CERTIFICATE OF APPROPRIATENESS

Property: 504 Avondale St, lot 2, tract 3A, block 6, Montrose Subdivision. The property includes a historic 3,124 square foot two-story residence situated and detached garage on a 7,800 square foot (60' x 130') interior lot.

Proposal: Alteration – Changes to the foundation, windows and porch

FRONT PORCH COLUMNS

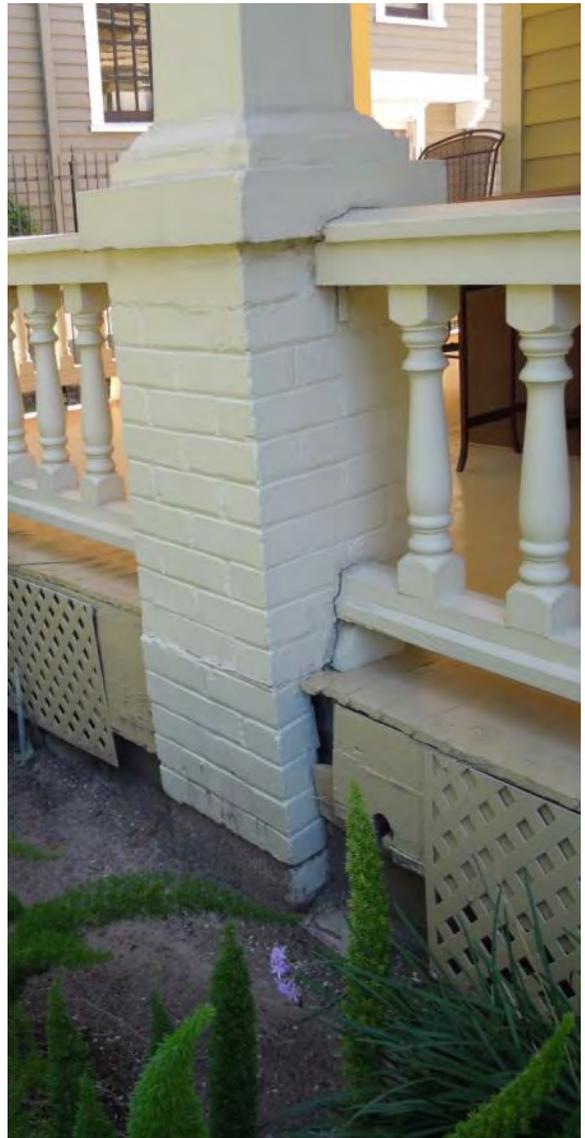
*FAILING PIERS AND
GRADE BEAM*

*FAILING PIERS AND
DAMAGED COLUMN*

Approval to raise the foundation, rebuild and repair the porch columns and install the corbels under the front porch eave.

WINDOWS

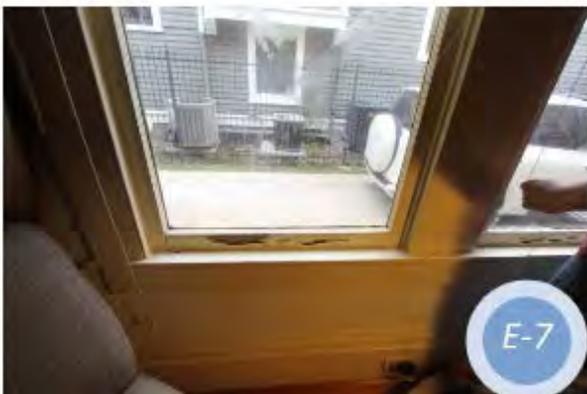
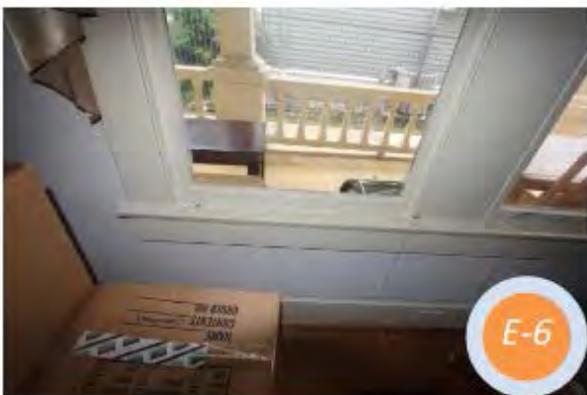
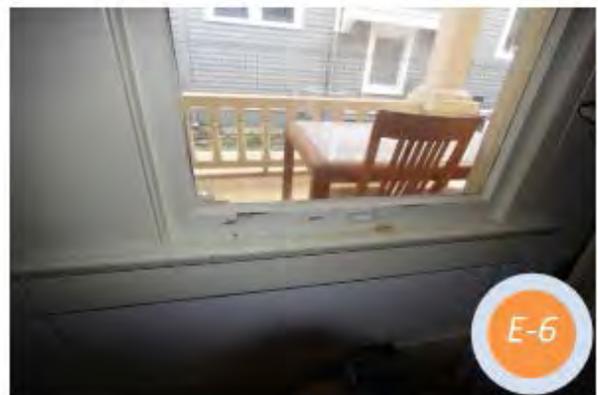
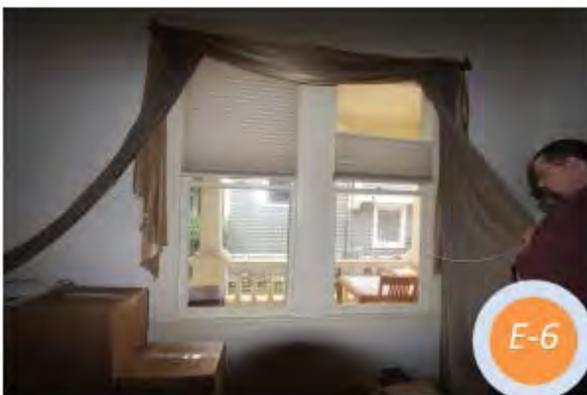
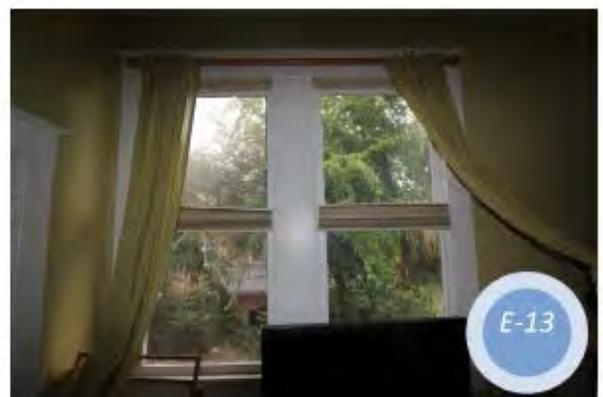
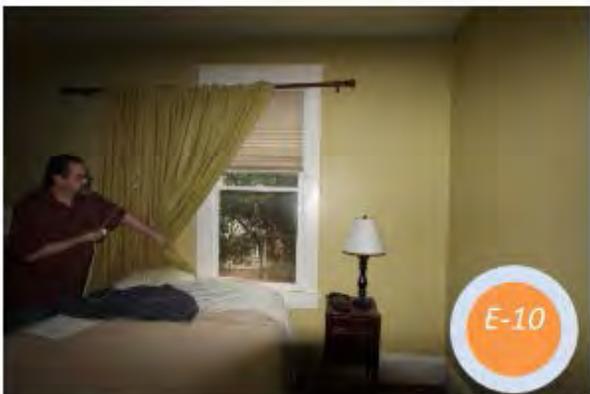
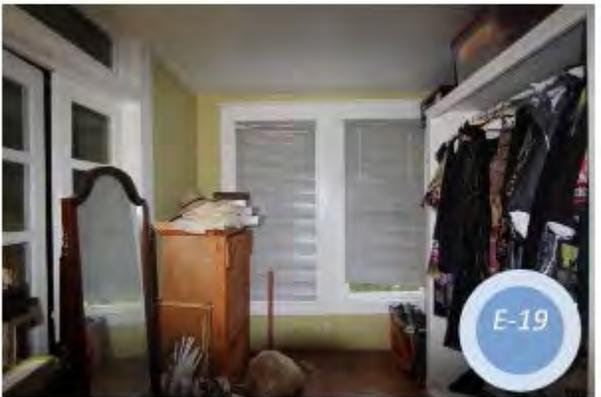
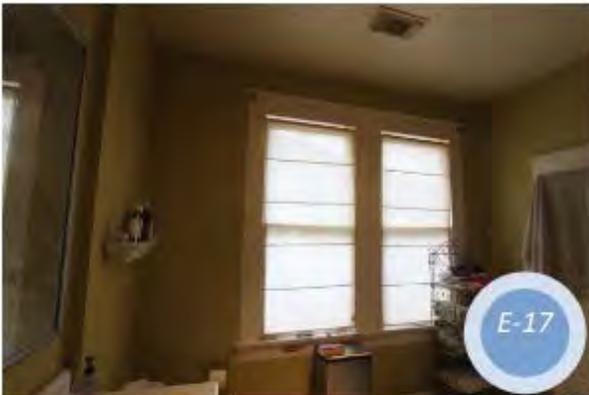
<i>The original wood windows are a distinguishing feature of the property and should be retained. Staff confirmed some damage of the original windows but believe they are not beyond reasonable repair.</i> | |

Broken window frame E-1, E-3, E-5, E-8, E-10, E-13, E-15, E-18, E-19

Rotten window frame E-7, E-9, E-14, E-16, E-17

Damaged window sill E-9, E-13, E-14, E-17, E-18, E-19

Denial to replace all wood windows with vinyl windows.

Denial to replace all wood windows with vinyl windows.

WINDOWS

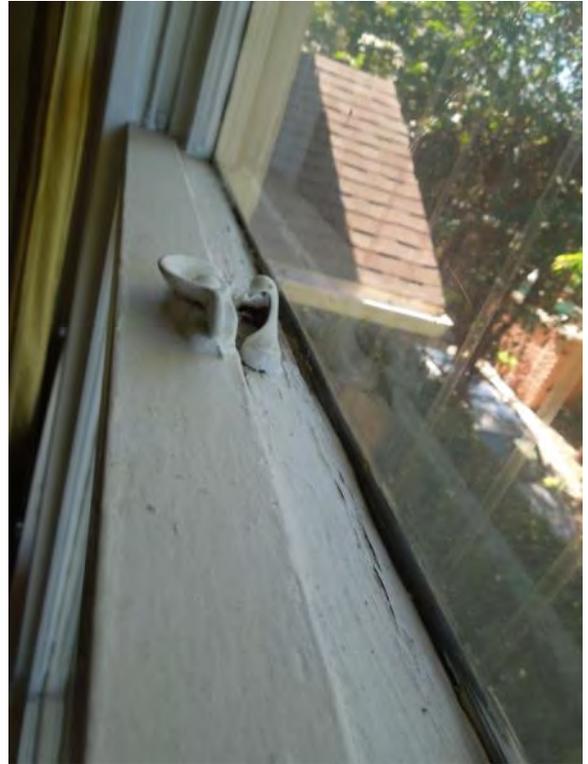
<i>The original wood windows are a distinguishing feature of the property and should be retained. Staff confirmed some damage of the original windows but believe they are not beyond reasonable repair. The replacement windows are compatible in size, scale, and character with the existing windows.</i> | |
